job no.	client	date:
BACTION LOW RISE	RYDON	01.16
drawing no.	scale:	job no.:
D-J-RC301	1:10 @ A1	1962
D-J-RC304	1:20 @ A3

DETAIL - Block C - D-J-RC301

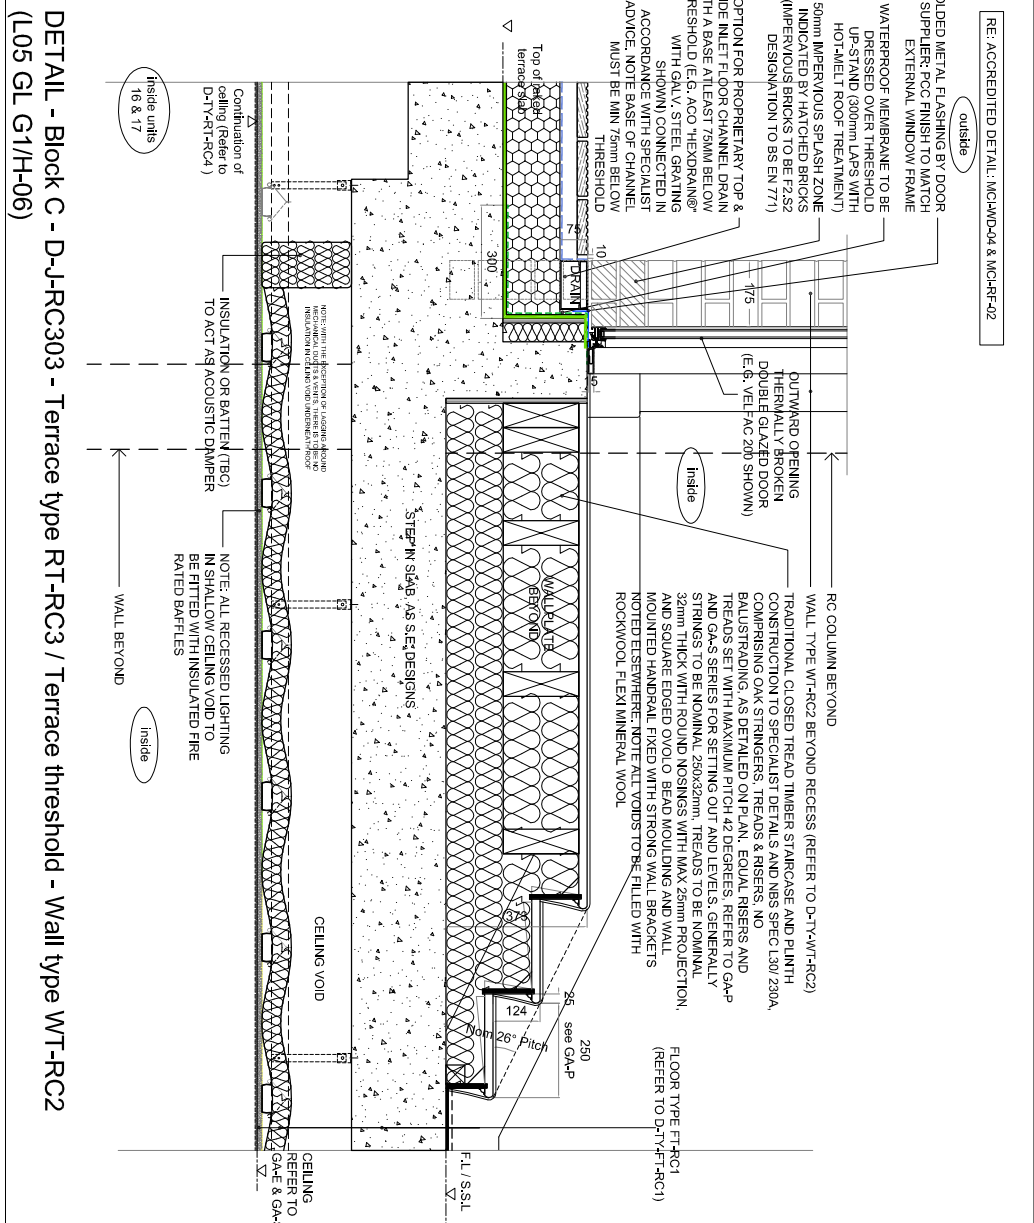
rev.	date	description	issued by	checked by
C1	20.01.16	First Construction Issue	RR	DWW
C2	04.05.16	Imperious splash zone indicated and depth of channel highlighted as per email comments dated 03.05.16	DWW	JD
